10 CFR 54
Docket No. 50-443
SBK-L-17180

Seabrook Station

Supplement 58 – Revised Alkali-Silica Reaction Aging Management Program

Enclosure 1 provides revised License Renewal Application (LRA) Appendix A - Updated Final Safety Analysis Report Sections A.2.1.31 for Structures Monitoring, A.2.1.31A for Alkali-Silica Reaction and A.2.1.31B for Building Deformation.

Figure 1 - Concrete Specimen put in Tension

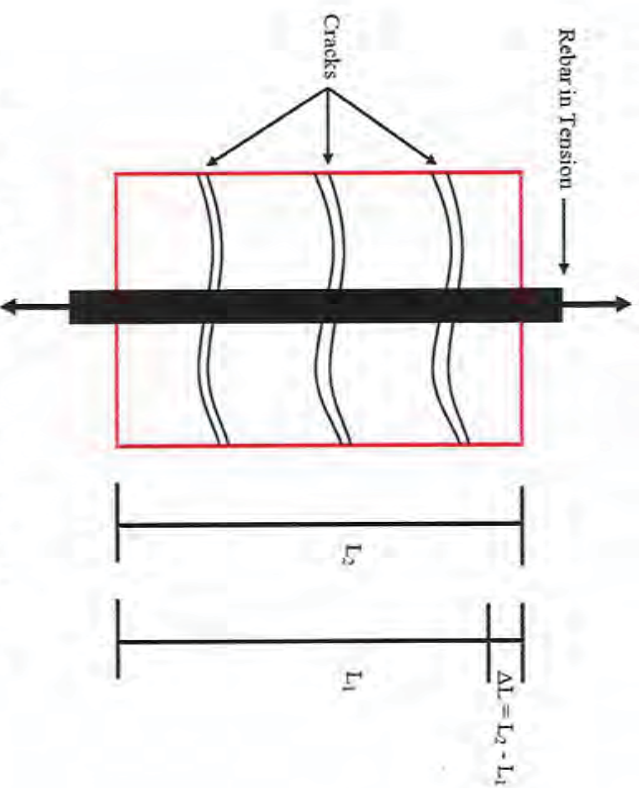
The engineering strain in a structural member at the time of crack initiation (ϵ_{ci}) is equivalent to the tensile strength of the concrete divided by the elastic modulus ($\epsilon_{cr} = \sigma_t / E$). The Cracking Index quantifies the extent of the surface cracking. The total strain in the concrete can be approximated as the sum of the strain at crack initiation plus the cracking index ($\epsilon \approx \epsilon_{cr} + CI$). Figure 1 depicts a concrete specimen with rebar being put in tension resulting in cracking.

Concrete has little strain capacity; therefore, in ASR-affected concrete, the crack widths comprise most of the expansion (ΔL). As a result, the Cracking Index provides a reasonable approximation of the total strain applied to the concrete after crack initiation, because strain in the un-cracked concrete between cracks is minimal.
